Sundry Print Report

Well Name: TSAH TAH 1 Well Location: T24N / R10W / SEC 1 / County or Parish/State: SAN

Notice of Intent

CONDITIONS OF APPROVAL

Planned Wellbore Schematic

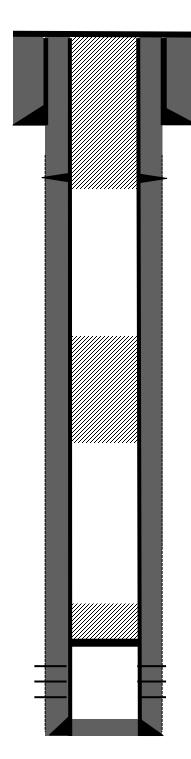
- 1. Plugging operations authorized are subject to the attached "General Requirements for Permanent Abandonment of Wells on Federal and Indian Lease."
- 2. Farmington Office is to be notified at least 24 hours before the plugging operations commence at (505) 564-7750.
- The BLM recommends to not perforate at 177'. Please contact Kenneth Rennick (krennick@blm,gov) or Matthew Kade (mkade@blm.gov) if there is a request to remove that procedure.

You are also required to place cement excesses per 4.2 and 4.4 of the attached General Requirements.
